Development Review Public Comment

LDC25-00003

2400 W 7th Street

Figure 4-16: Parcel Size Matching

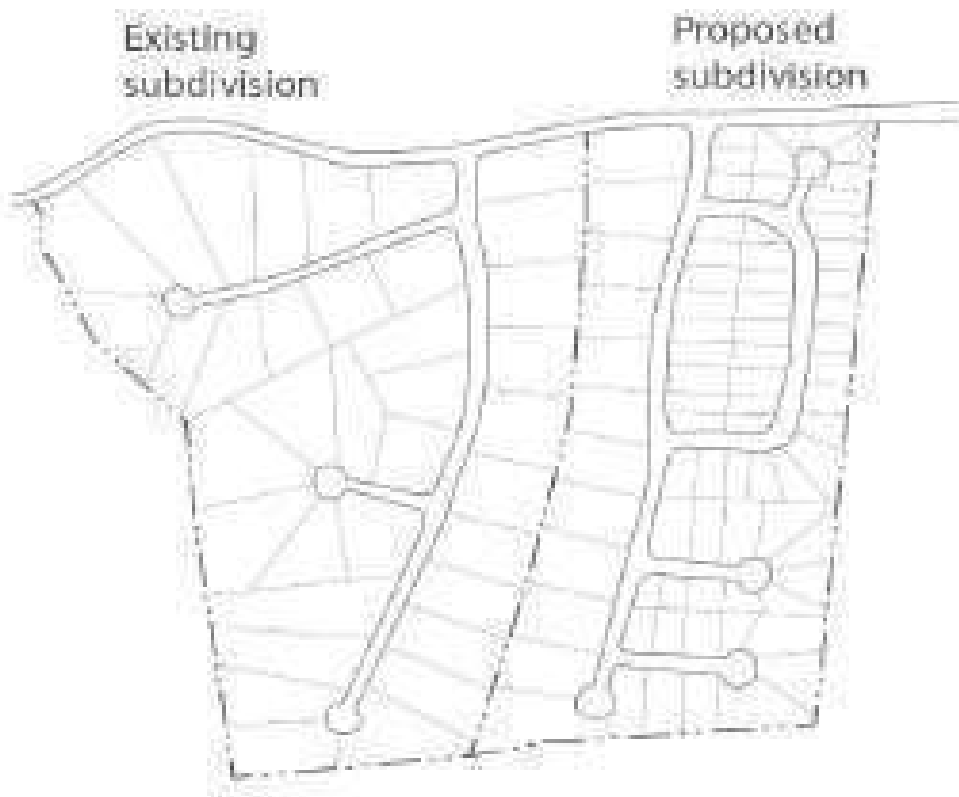
Parcel Size Matching states, “The minimum lot sizes identified in the land use designation of the immediately adjacent property shall be maintained at the edge of the proposed subdivision as depicted in Figure 4-16”

The Western boundary, shown in the Preliminary Lot and Block Plan, shows three different buffer widths. 23 feet, 17 feet then all the way down to 5 feet, between the property line of lot 11 and the neighboring development fence. The developer stated at the N.A.B they have a 37-foot buffer. They are measuring from the neighboring development fence line all the way to the physical home being built not the property line. Code shows that it is from the property line of the existing development to the property line of the proposed development, not structure to structure. The developer must draw new plans for the entire Western boundary creating a 30-foot buffer. This code is black and white there is no way around it.

Figure 4-18: Yard Matching

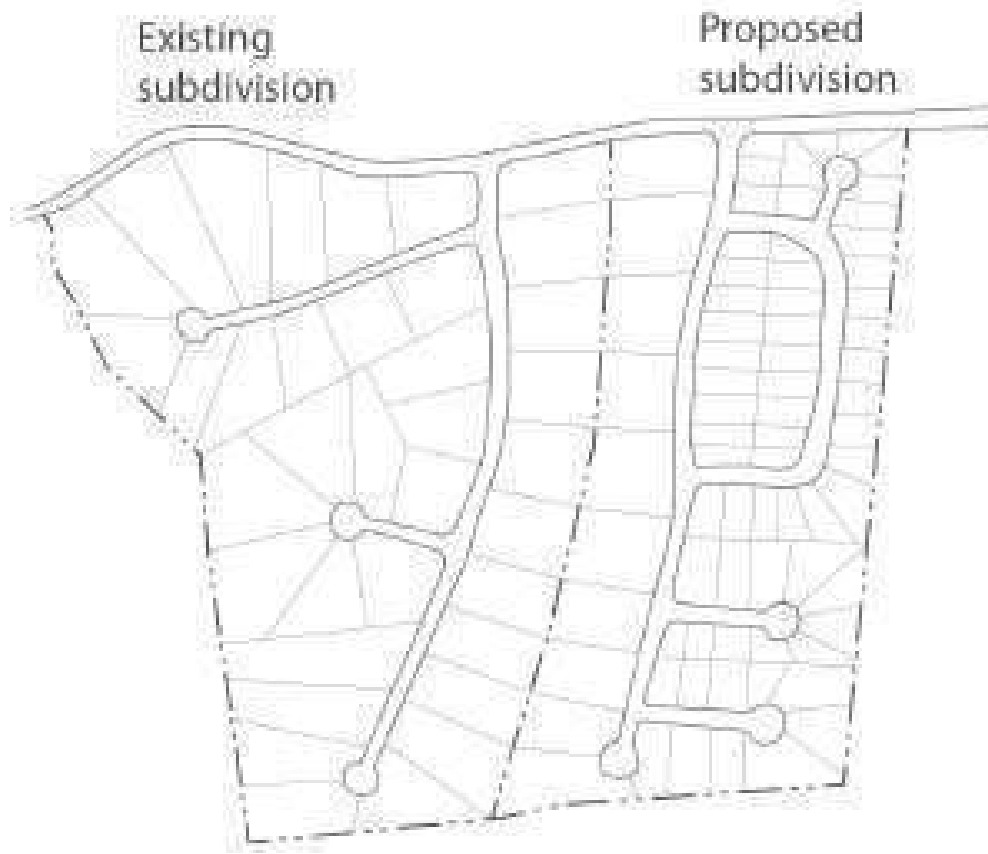
Yard Matching states “The rear yard widths of the proposed development shall match the rear yard widths of the existing development as depicted in Figure 4-18.”

There is no caveat for this code and buffering does not appear to apply. As the code reads the widths of the existing subdivision and proposed subdivision must match. The proposed subdivision rear yards are approximately half the size of the existing subdivision.

Wood Rodgers Elevation and Grading 2605 and 2615 Everett Dr

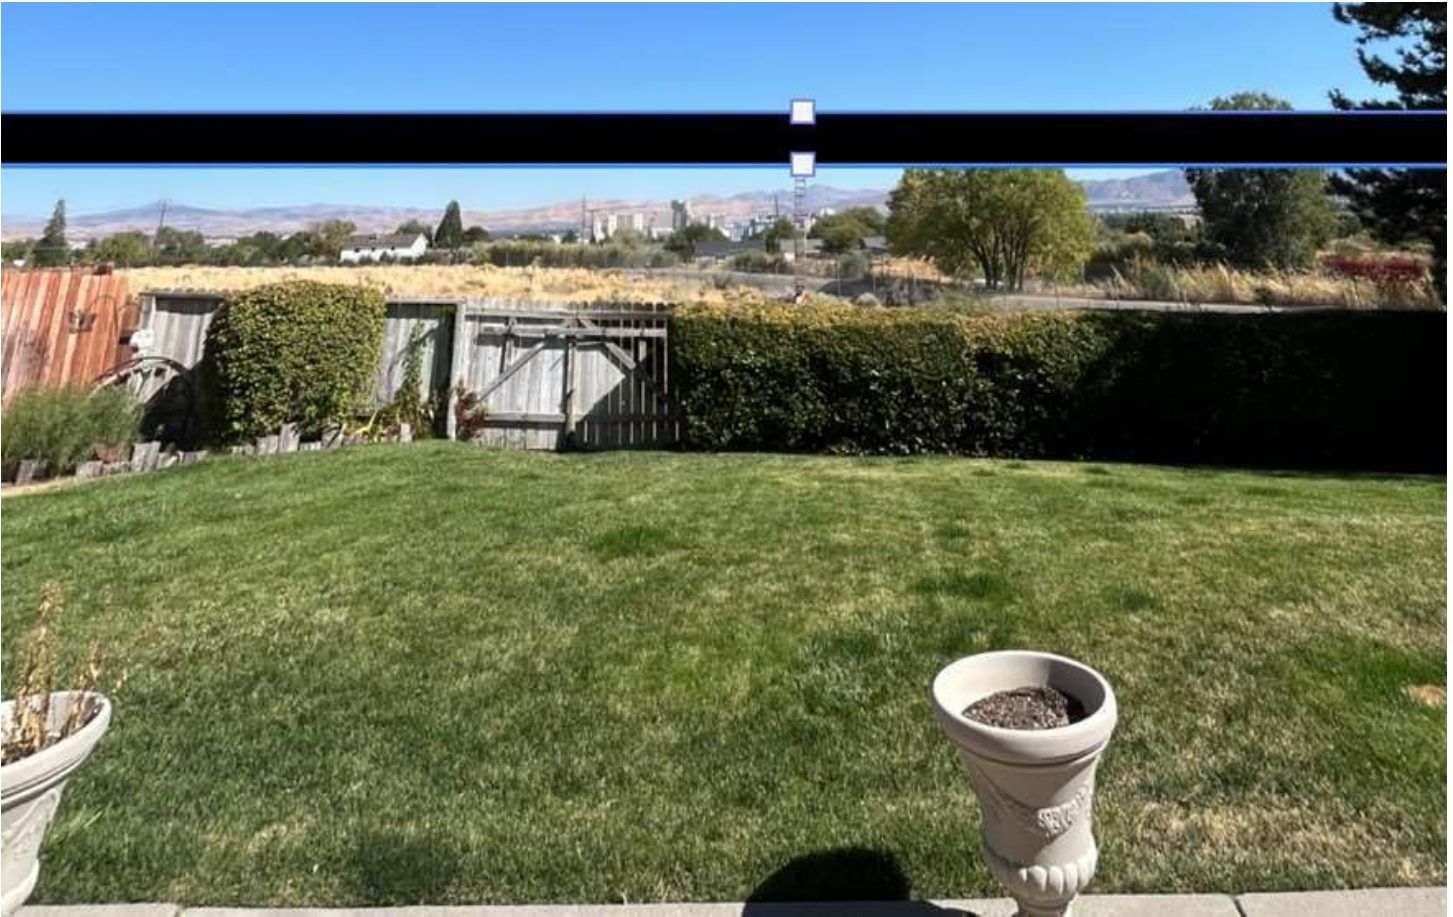
Pictures of where rooflines will approximately fall. Homes on SE boundary do not allow views between houses due to 45 degree offset.

2615 view from back patio to estimated height of home 13 (point E). 28' roofline. From highland ditch grade/base elevation. (Home 11 will be much more obtrusive due to closer proximity.)

2605 Everett view from 2nd story deck to estimated height of home 14. 28' roofline. From highland ditch grade/base elevation.

Proposed homes will need to sit slightly higher than base grade level to allow for drainage away from home. Rooflines will sit slightly higher than pictured above.
